Access Compliance Report

Public Rights-of-Way

Intersection ID: 45775	Main Street: BITTER_CREEK_DR	Cross Street: CARVER_FALLS_RD	Location:	N
ADA ID: ABF42007CCBB	Ramp Type: PerpDiag	Initial Pass/Fail: Fail	Overall Compliance: No	Severity Score: 10

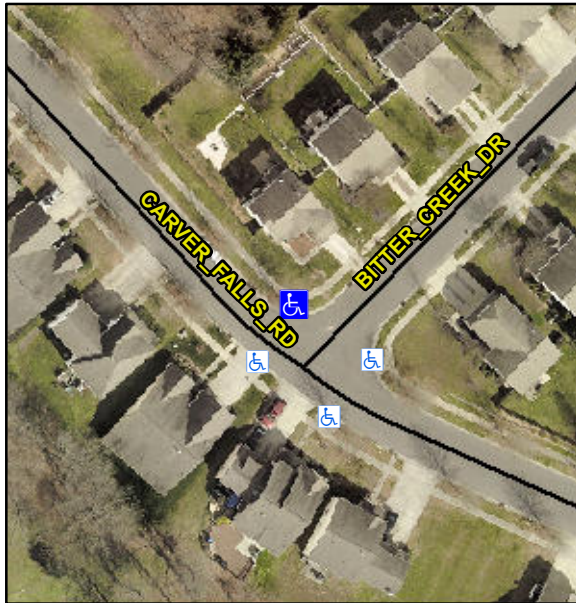
R304.5.1, R304.5.3

Compliance	Description	Data	Compliance	Description	Data
N/A	Ramp Length (in)	73.0	Yes	Ramp Slope (%)	5.0
No	Ramp Width (in)	47.5	No	Ramp XSlope (%)	4.0
N/A	Flare Type LT	N/A	N/A	Flare Type RT	N/A
N/A	Flare Slope LT (%)	N/A	N/A	Flare Slope RT (%)	N/A
N/A	Flare Traversable LT?	N/A	N/A	Flare Traversable RT?	N/A
N/A	Landing Length (in)	N/A	N/A	DWS Provided?	N/A
N/A	Landing Width (in)	N/A	N/A	DWS Contrast?	N/A
N/A	Landing Slope (%)	N/A	N/A	DWS Length (in)	N/A
N/A	Landing X Slope (%)	N/A	N/A	DWS Full Width?	N/A
N/A	Landing Curb? (Y/N)	N/A	N/A	DWS Offset (in)	N/A
N/A	Shared Landing?	N/A			
N/A	Gutter Ponding?	N/A	N/A	Gutter Slope (%)	N/A
N/A	Gutter Lip Ht (in)	N/A	N/A	Gutter X Slope (%)	N/A
N/A	Painted X Walk1?	No	N/A	Painted X Walk2?	No
	X Walk 1 Direction	To SW		X Walk 2 Direction	To SE
N/A	X Walk 1 Width (in)	N/A	N/A	X Walk 2 Width (in)	N/A
	X Walk 1 Slope (%)	3.3		X Walk 2 Slope (%)	1.3
	X Walk 1 X Slope (%)	3.2		X Walk 2 X Slope (%)	1.9

Remove & Replace Curb Ramp With Two New Directional Ramps or Equivalent.
